PRODUCT CHANGE NOTIFICATION

Select Bourns® Shielded Power Inductors

Manufacturing Site Relocation and Process Automation

IC24174

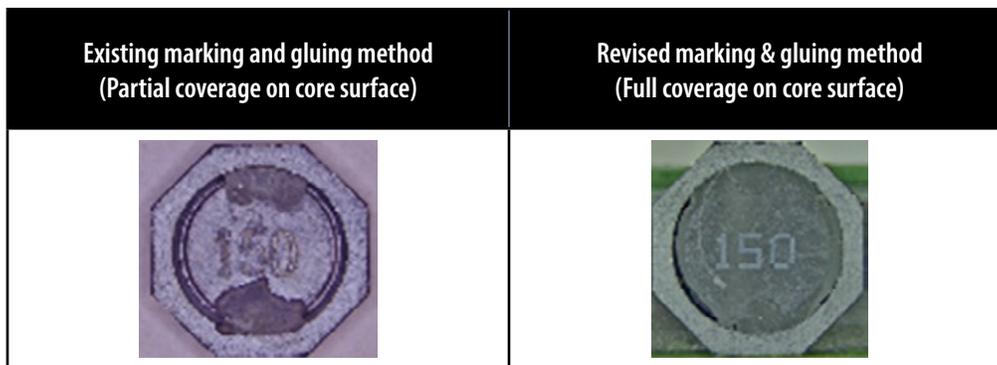
Bourns will also change its gluing, marking, testing, and taping processes to automated processes. Additionally, the marking method will be changed from laser to inkjet and the gluing method will have a larger application area. A list of affected part numbers is included below.

The fit, function and country of origin of the affected part numbers will remain the same. The form will change slightly due to the change to the marking method. The quality and reliability of the affected inductors should be improved as a result of the changes. Traceability will be maintained through lot code and date code.
